CITY OF BOULDER
PLANNING BOARD MEETING AGENDA
DATE: August 18, 2016
TIME: 6 p.m.
PLACE: 1777 Broadway, Council Chambers

B. AGENDA TITLE: CONCEPT PLAN & REVIEW - Redevelopment of the existing seven-acre apartment site located at 1550 Eisenhower Drive with a new three-story apartment complex Eastpointe Apartment Homes, consisting of 236 proposed units in five buildings with below grade parking and on-site recreational amenities under case review no. LUR2016-00043.

AGENDA TITLE: CONCEPT PLAN & REVIEW - Redevelopment of the existing seven-acre apartment site located at 1550 Eisenhower Drive with a new three-story apartment complex Eastpointe Apartment Homes, consisting of 236 proposed units in five buildings with below grade parking and on-site recreational amenities under case review no. LUR2016-00043.

Figure 9: Urban Design Suggestions to Applicant regarding Concept Plan

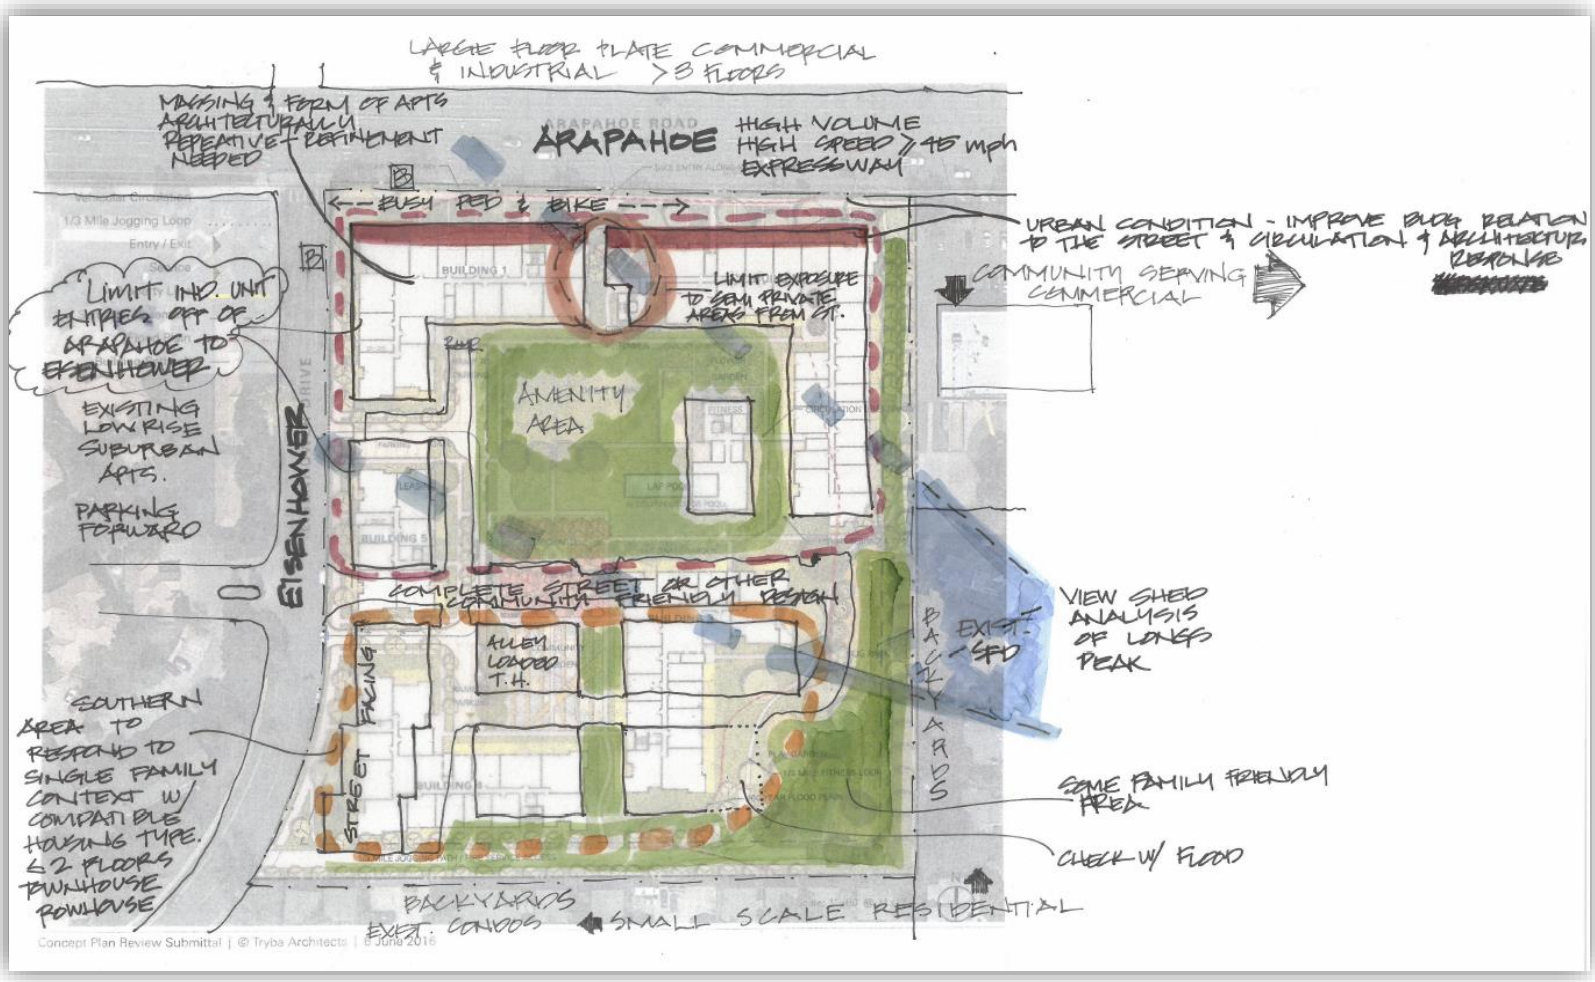
Recognizing the high density land use and zoning on the site and the typology of Arapahoe Avenue, the northern portion of the site can accommodate bigger buildings and a greater degree of intensity however, the proposed site plan should consider the existing surrounding residential uses that are smaller in scale and stature, particularly the single family detached homes to the south. The Site Plan should consider the following to better address the context and surroundings, and as shown in the graphic on the following page in **Figure 9**:

- Break up the superblock by creating a distinct transition to a less massive building type and units on the south side of the site, with the transition being a complete street as shown in **Figure 9**.

- Limit individual unit entries off of Arapahoe Avenue, given the high volume arterial, and instead provide for overall building entries off Arapahoe and individual unit entries off of Eisenhower.

Figure 11: Exterior Material Proposal

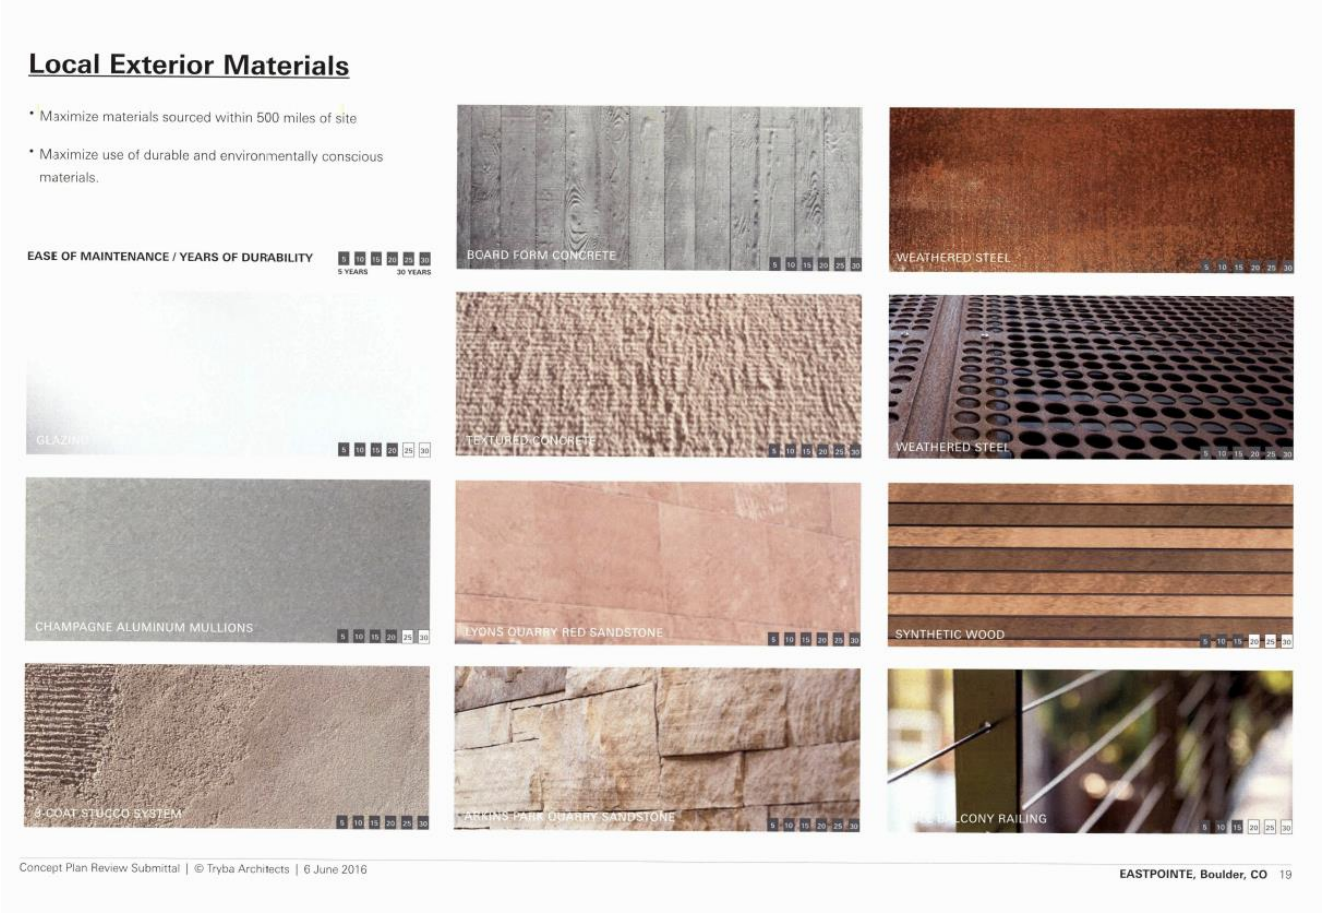
- As discussed with the applicant in a review of the comments, staff and the applicant concurred that some edges or portions of buildings should be converted to two-story massing. Similarly, while the early proposal for exterior materials (shown in **Figure 11**) does appear to be durable and of high-quality, staff recommends reconfiguring the finish materials distinctly on different buildings, such that the buildings don't appear as a duplications of one another.

Diagram #1a - Site Plan Development

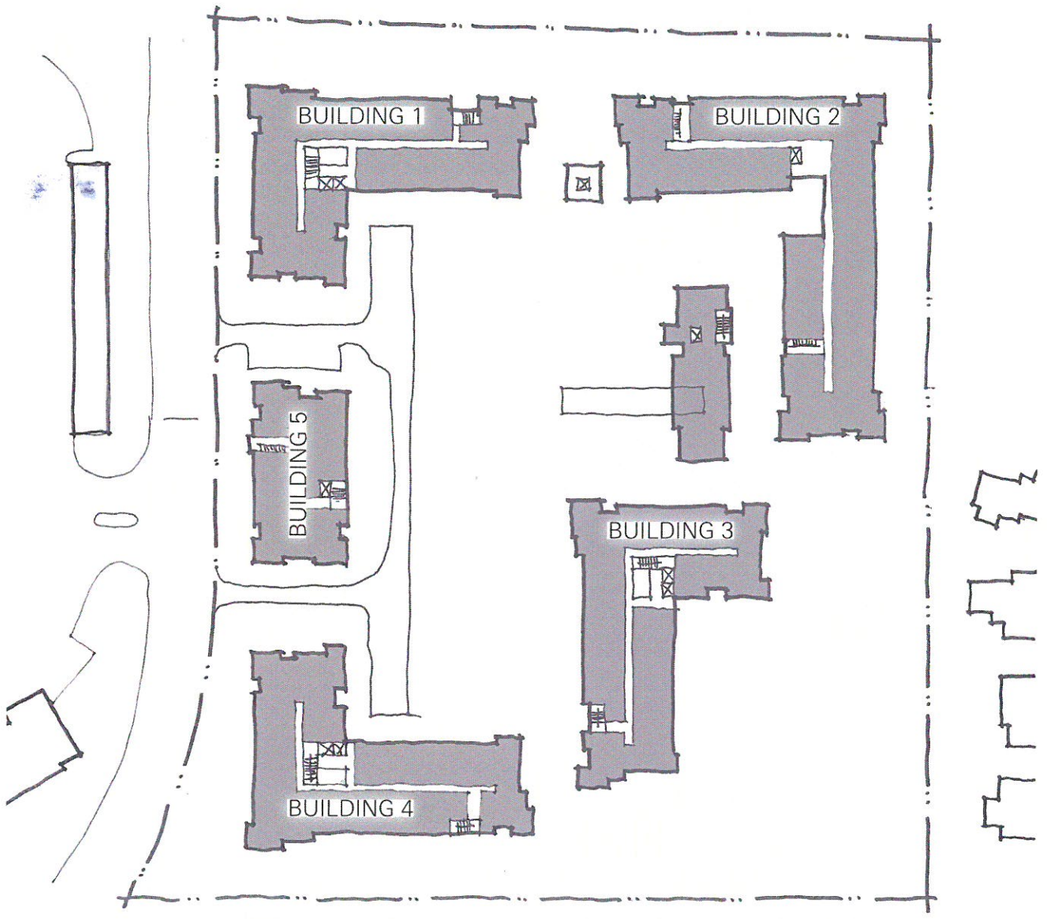
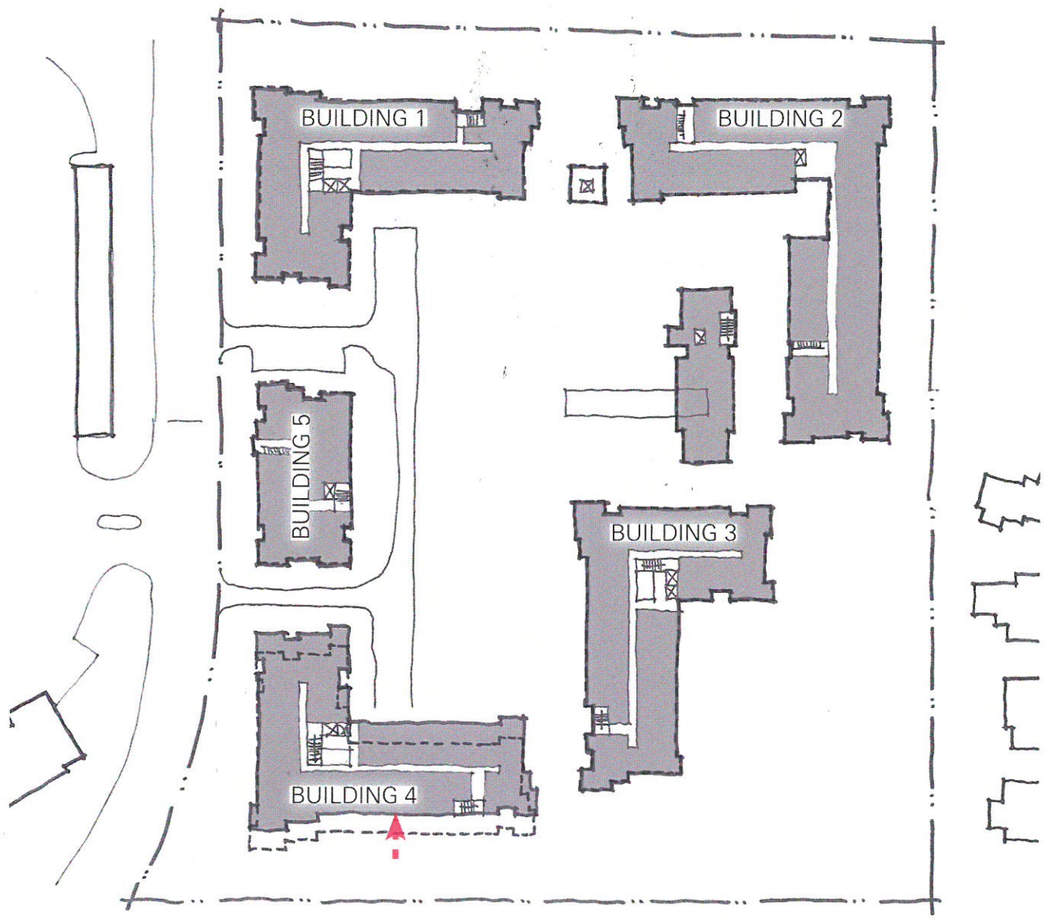
MOVE BUILDING 4 NORTH 12 FEET

- TO MAINTAIN VIEWS FOR NEIGHBORS

Diagram #1b - Site Plan Development

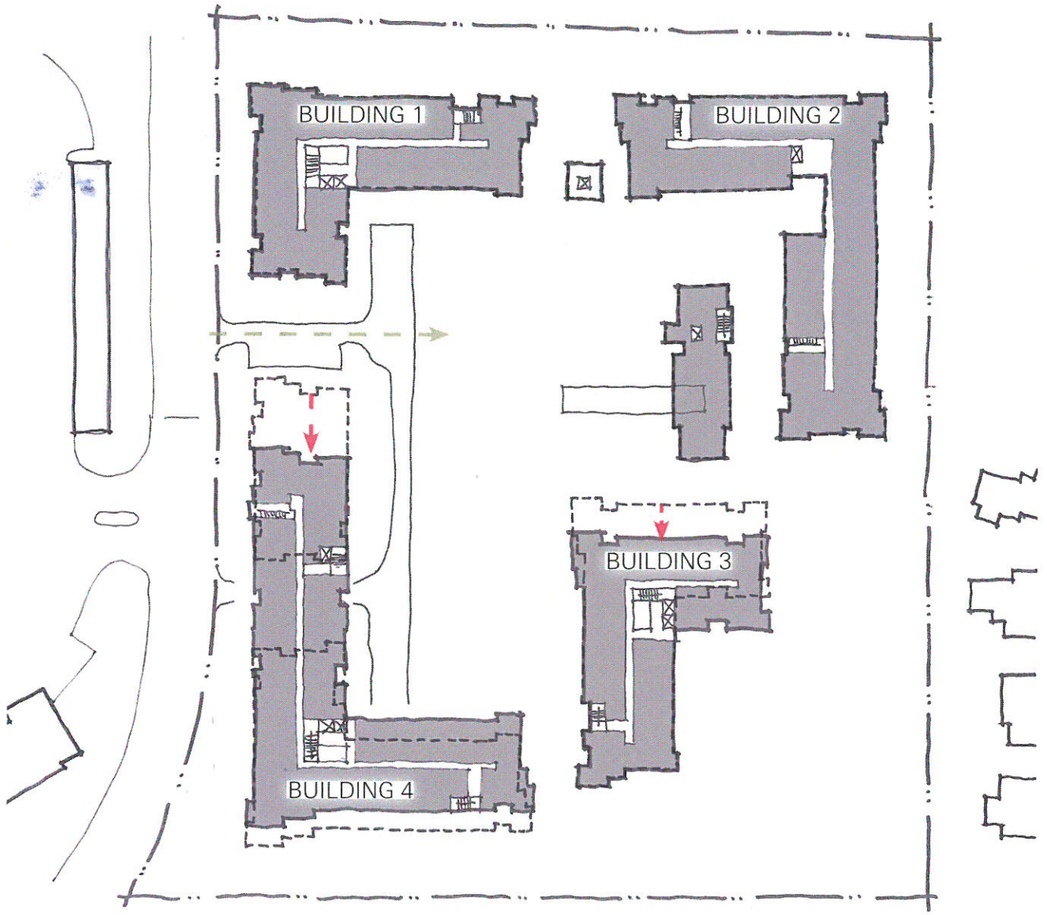
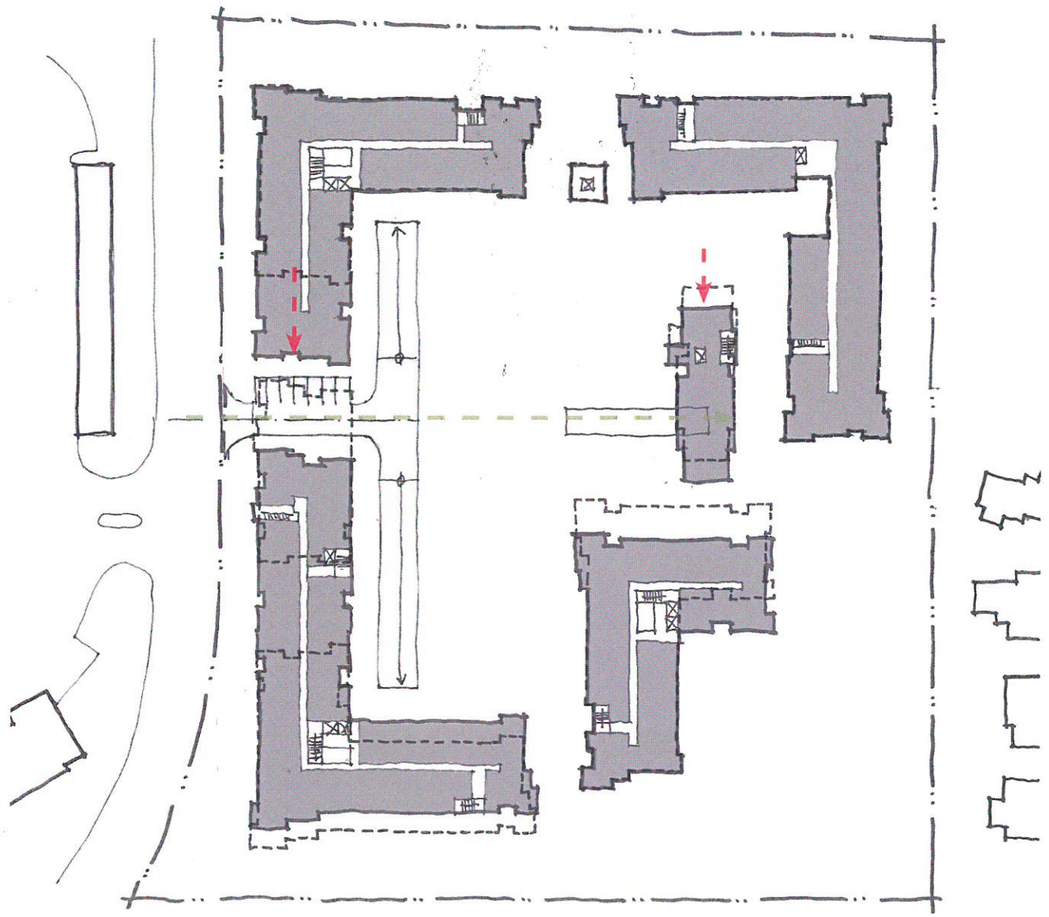
INTEGRATE SINGLE ACCESS POINT

•MERGE BUILDINGS 4 AND 5 TO ALLOW FOR SINGLE ACCESS POINT

Building Design (Elaine McLaughlin, 303-441-4130)

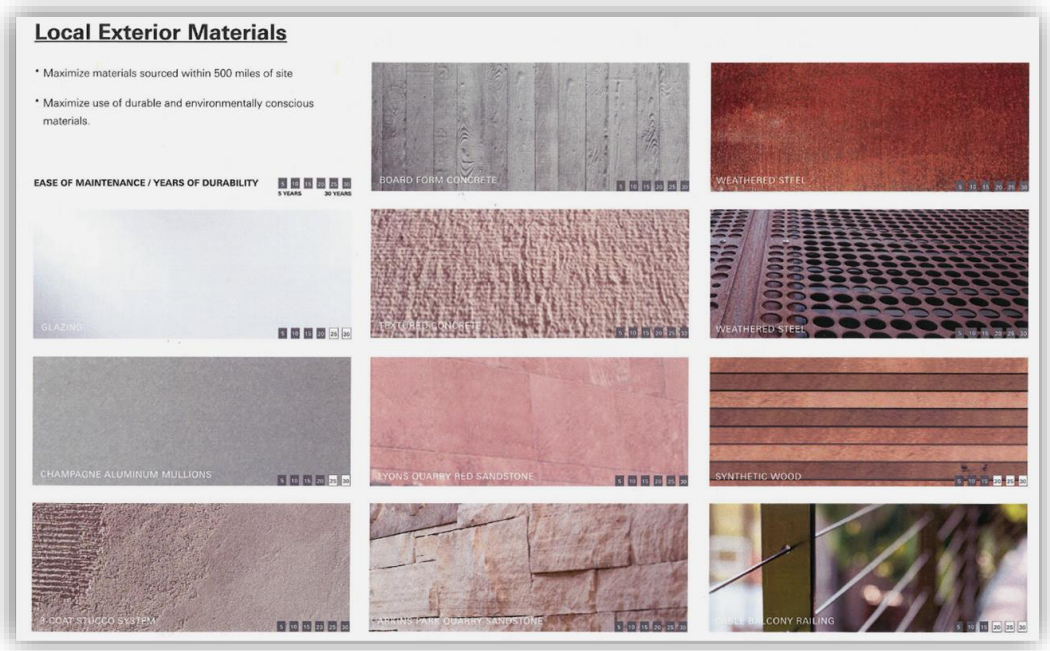
1. While early in the planning process, the applicant provided a strong palette of materials. As project plans progress, the applicant should reference the Site Review criterion (9-2-14(H)(2)(F)(xii) that requires, "*Exteriors of buildings present a sense of permanence through the use of authentic materials such as stone, brick, wood, metal or similar products and building material detailing."* While most of the palette appears to address this criterion, the applicant should consider less use of "stucco" as a primary finish material.

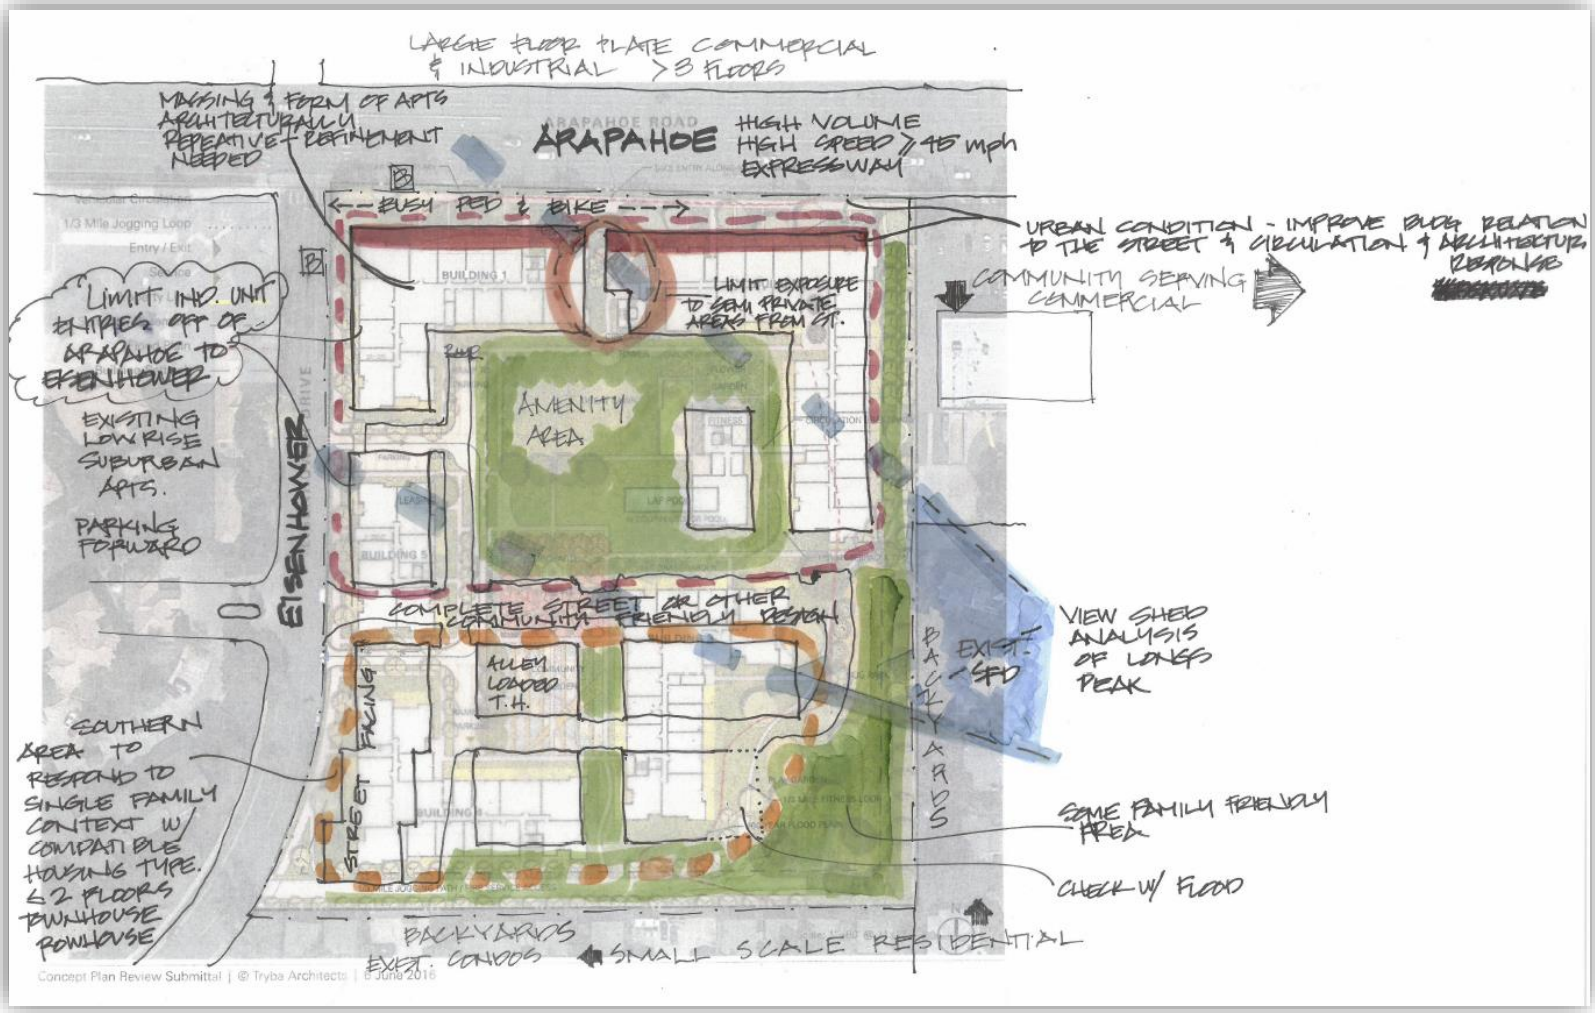
- Setback units from southeast property line and perform a viewshed analysis from adjacent neighborhood to preserve view corridors to the northwest
